SUMMIT LAND PARTNERS – CANYON VIEW PROJECT
Planned Development and Major Architectural Approval – Response to March 11, 2015 Planning Commission Study Session

Planned Development and Major Architectural Approval – Response to February 16, 2016 Architectural Advisory Committee Proposed Conditions

Case 5.1384 – PDD 381 / 3.3902-MAJ – VTTM 36969
 08-10-2016 Planning Commission
 Draft Small Lot Ordinance Comparison

ARTICULATED
PERIMETER WALL

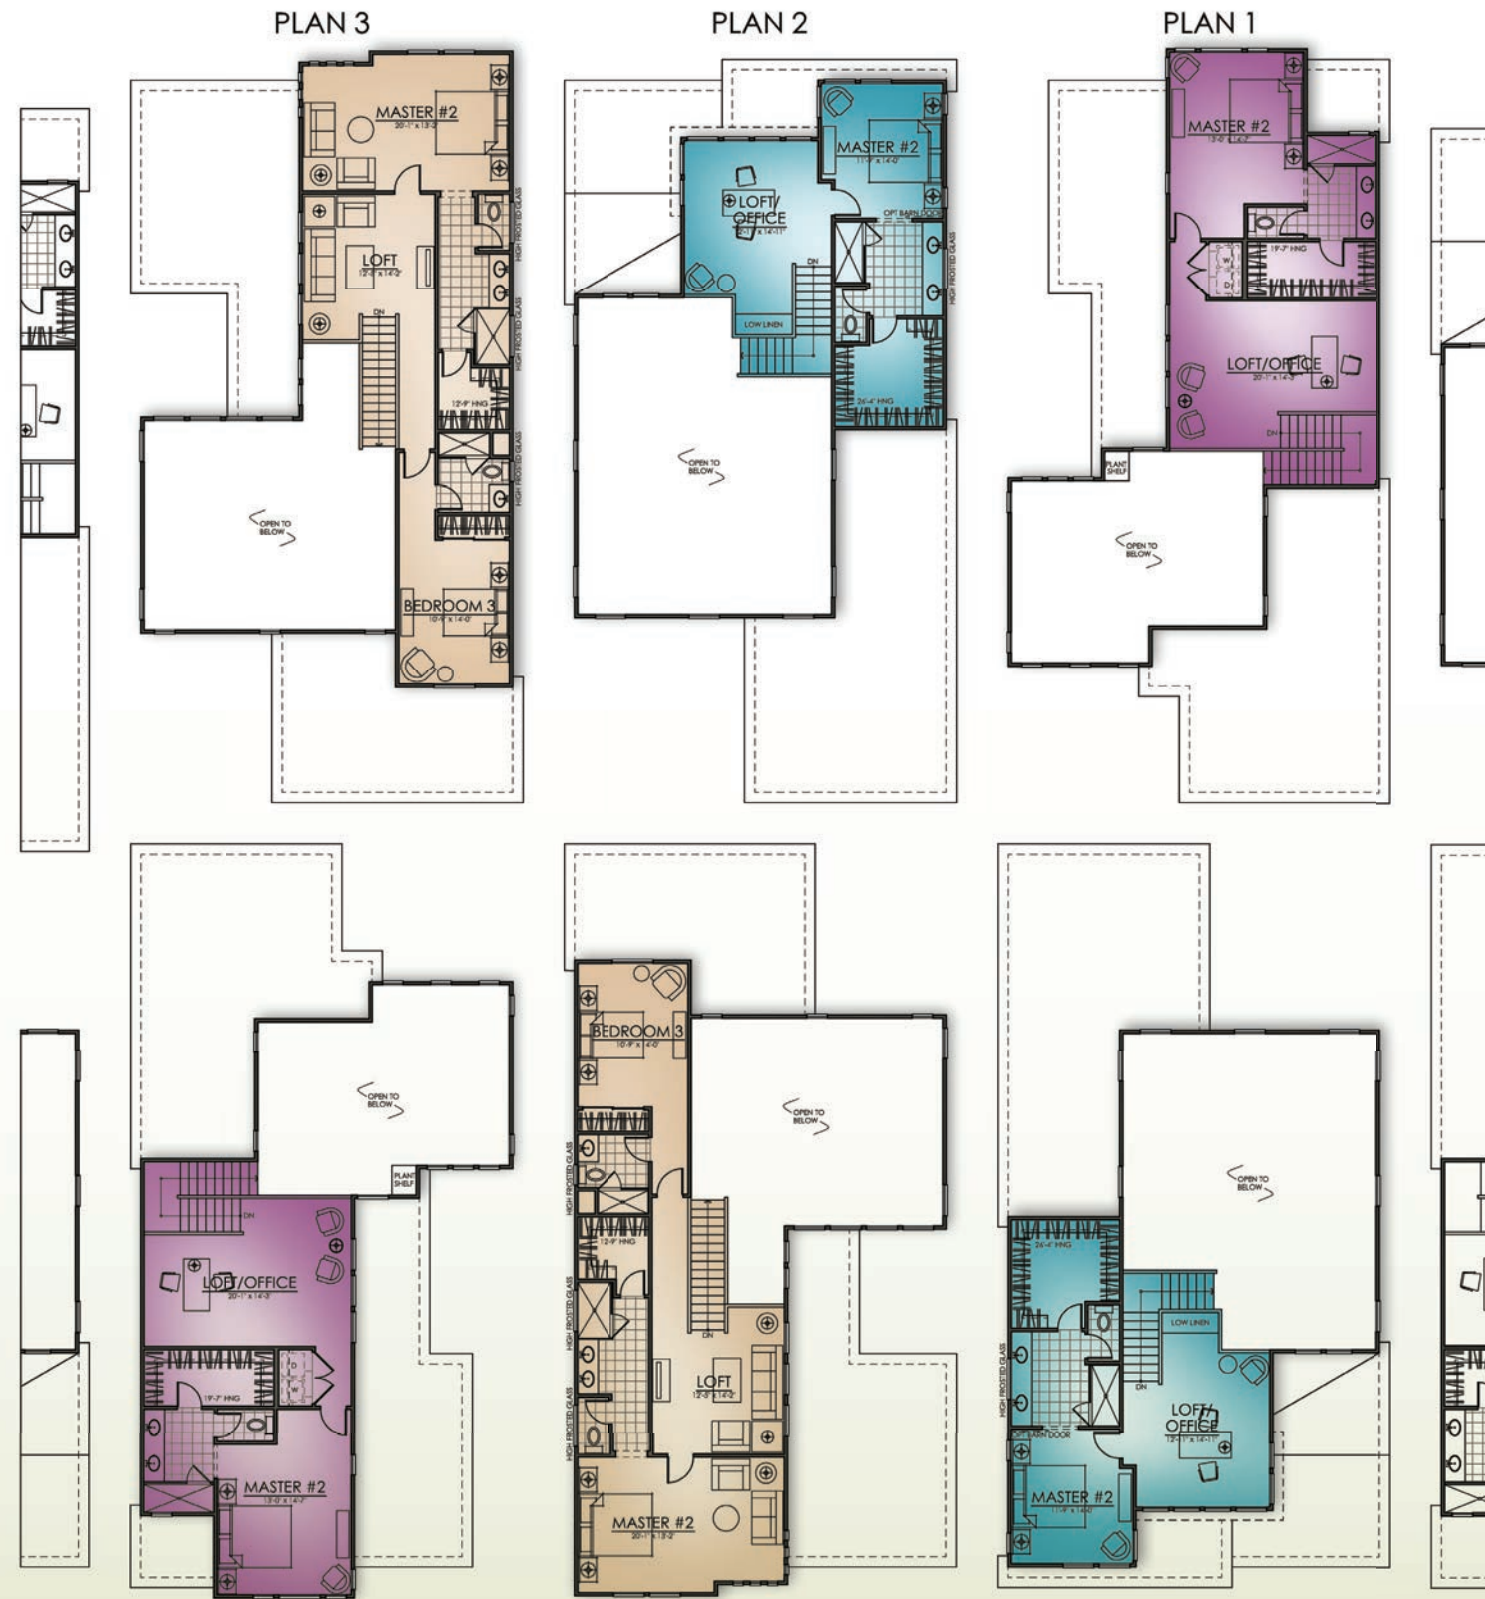
4. Can rear yard walls be articulated along perimeter streets?	<p>Done.</p>	Yes.

VESTING TENTATIVE TRACT MAP 36969 | CITY OF PALM SPRINGS

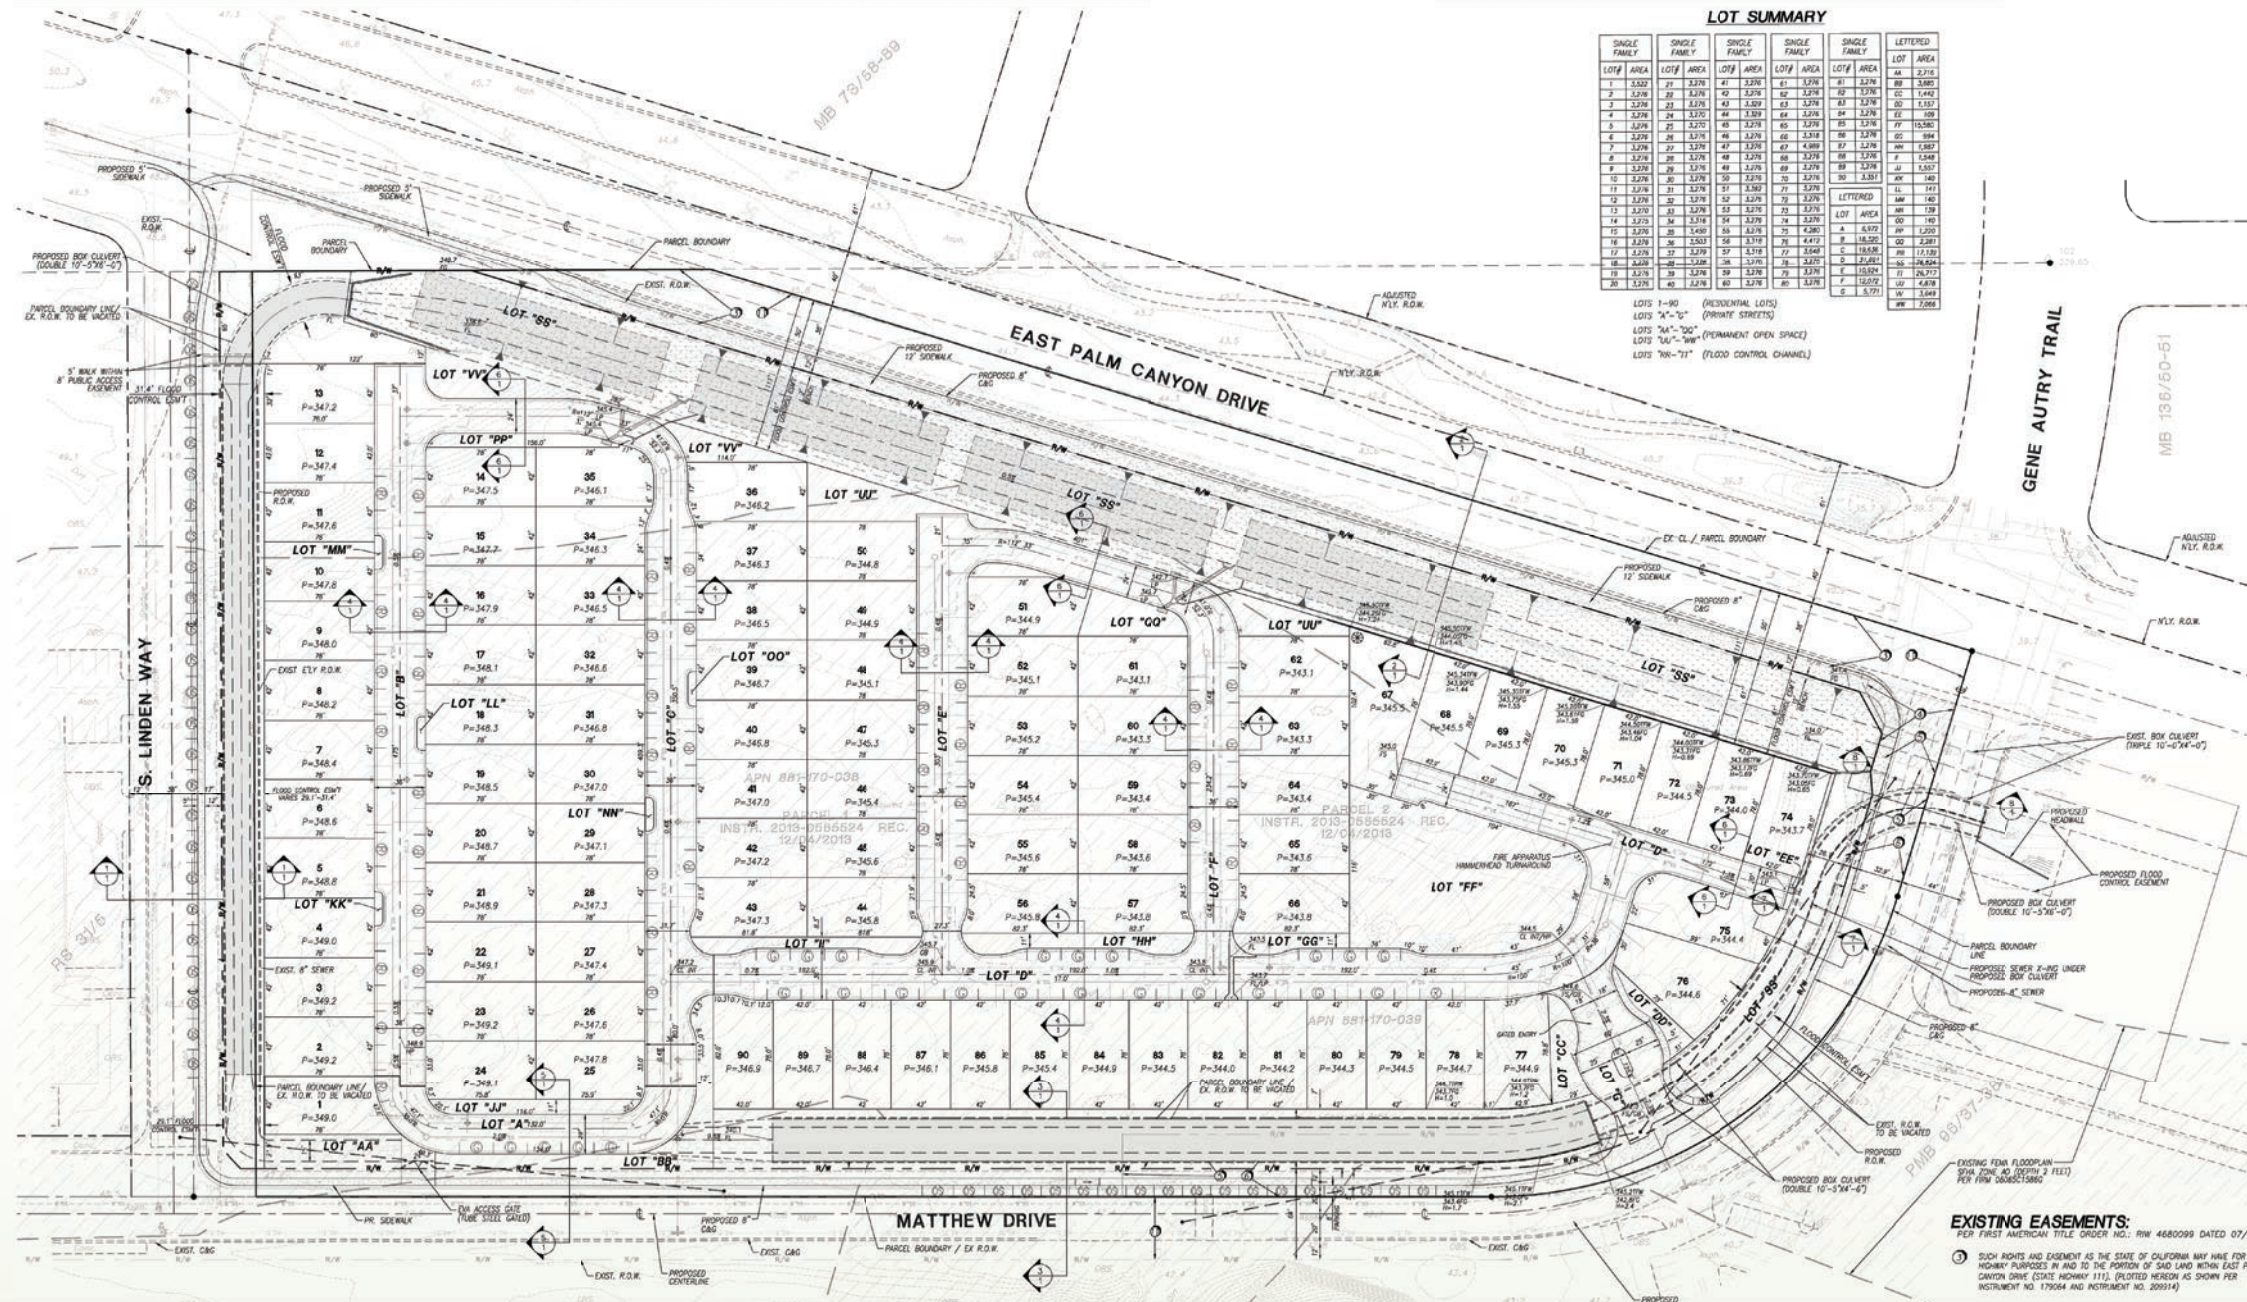
MARCH 11, 2015 PLANNING COMMISSION STUDY SESSION COMMENTS	SUMMIT RESPONSE	COMPLIED WITH REQUEST
LOWE		
1. Can 'U' streets be modified to created additional open space, blending with the E. Palm Canyon Channel?	Can comply, however, creates awkward dead-end street condition. Planning staff strongly recommends against dead end streets.	Yes / No
MIDDLETON

<p>5. Eliminate dead end streets; improve quality of exterior space – possibly greater setbacks</p>	<p>Converted dead end streets to through streets; deleted 2 lots and added 1/3-acre private Social Garden with interactive fountain, communal areas, barbecue and shade trees. Being located at main entry provides a wonderfully welcoming entry experience; this location also allows for those who prefer to be near this feature as well as those who prefer to be more remote. The Social Garden is within walking distance of all residents and designated guest spaces are immediately adjacent.</p>	<p>Yes</p>
